## **PORT & MARINE SERVICES**

### **ADDENDUM NO. 2**

#### **CCTV SURVEILLANCE SYSTEM BIGHT MALLORY SQUARE & OUTER MOLE ITB #18-015**

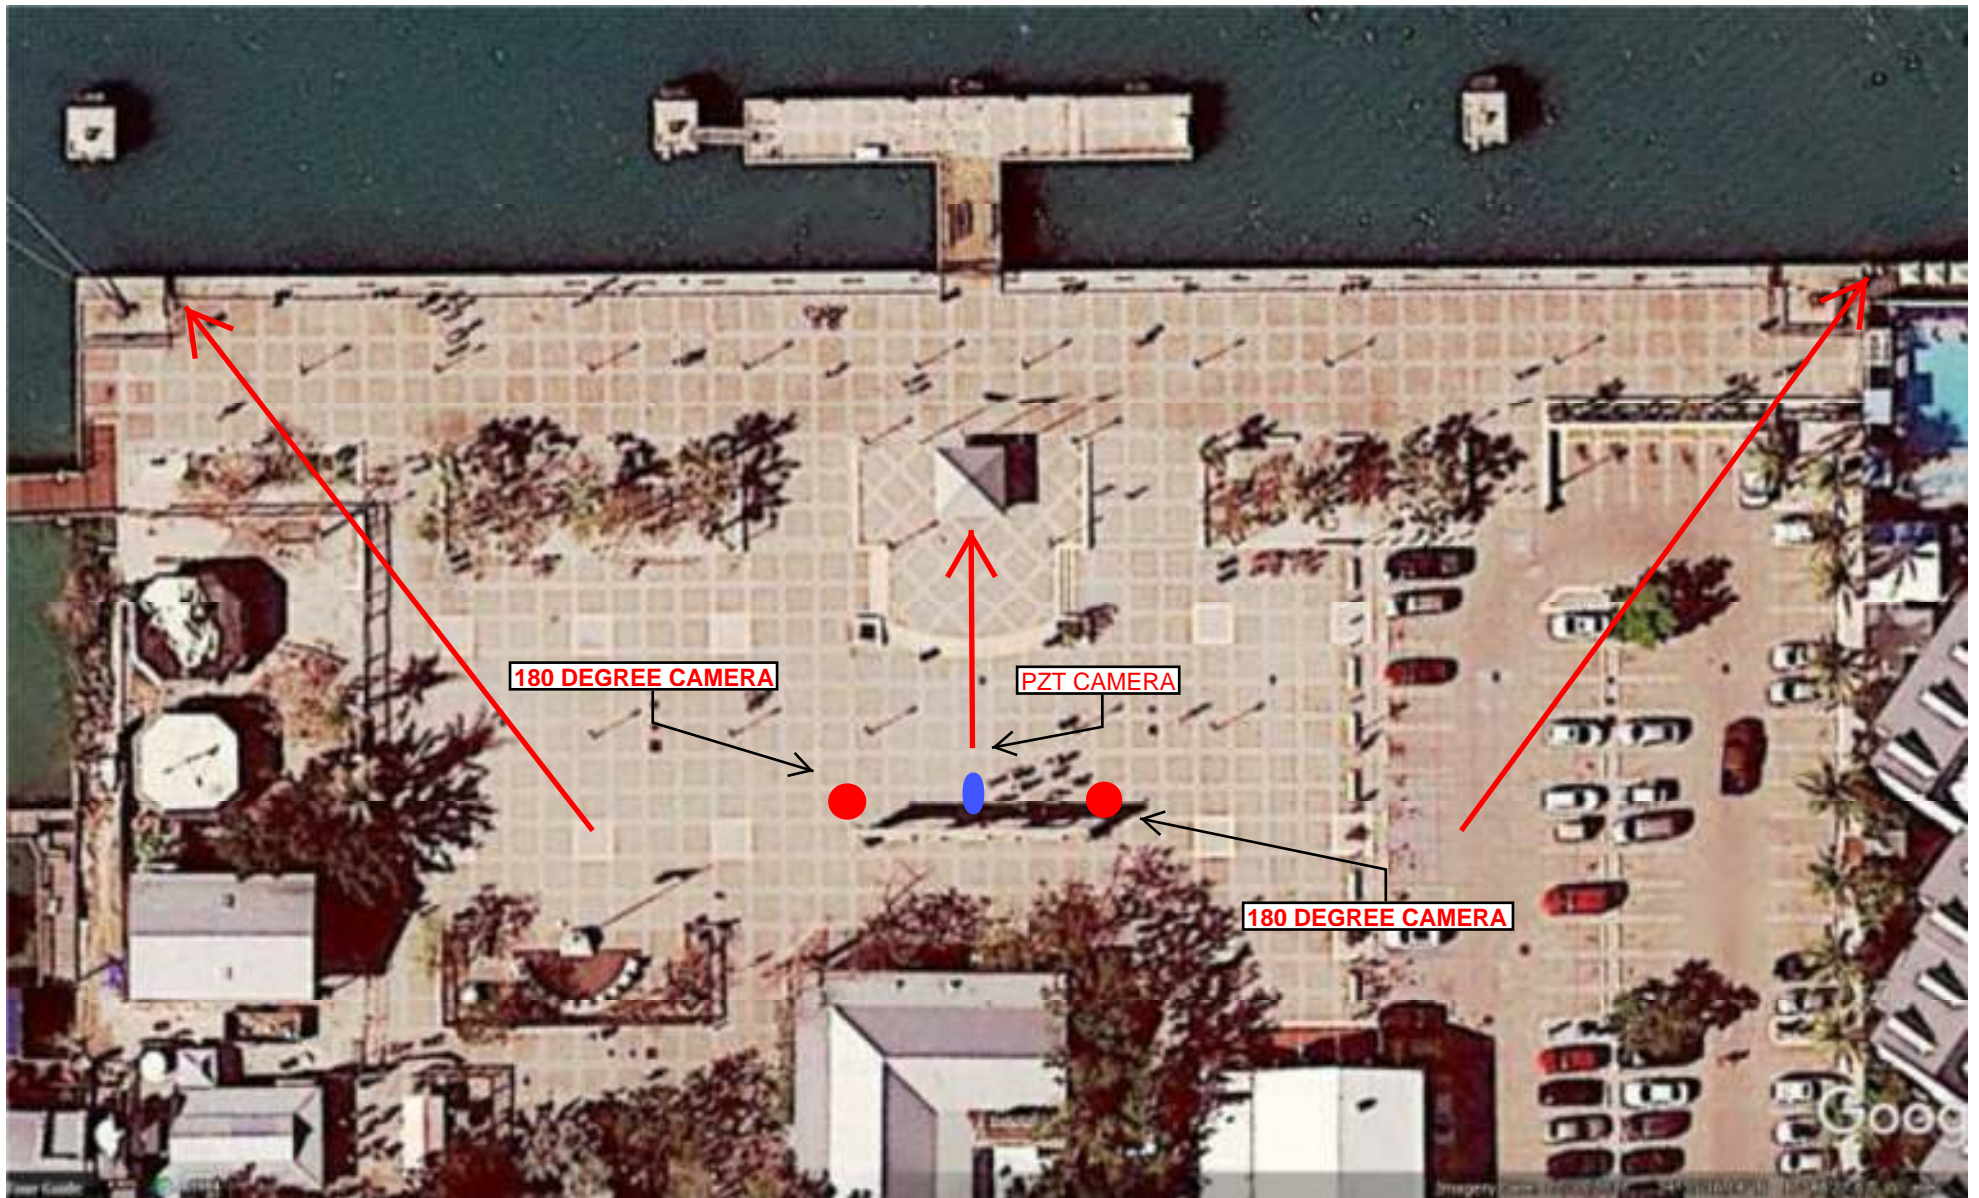
5. Based on the information provided in the summary of work it is unclear to the amount of cameras and/or the area of coverage requested at each location. Can a map with color coordination be provided to identify the coverage areas that are required?

**Revised Bid Form, Summary of Work and new location maps attached.**
